MODIFICATION RECOMMENDED

33220A-02B

33220A - 20 MHz Function/Arbitrary Waveform Generator

Encoder May Be Subject to Early Failure

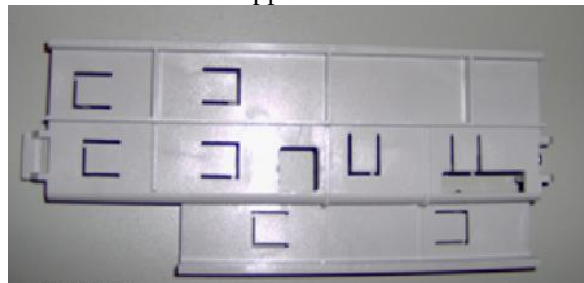
Customers have the option of repairing their own instruments by following the instructions on the subsequent pages. First order 33220-80002 front panel kit. The kit contains 3 parts:

Front Panel Board

Support Plate

Flat Flex Cable

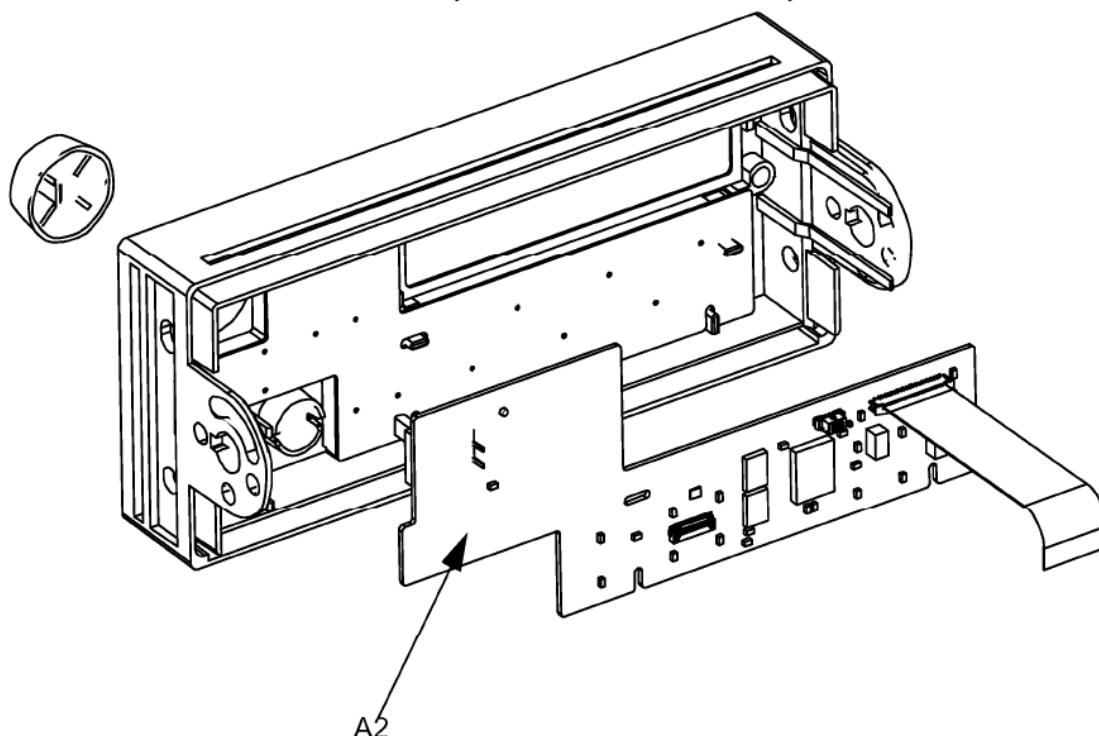
3. Pull to remove the knob. Lift out the keyboard PC board (A2 assembly).

4. Replace the following assemblies:
 - A2 front panel board, part number 33220-66512
 - Support plate, part number 33220-04112
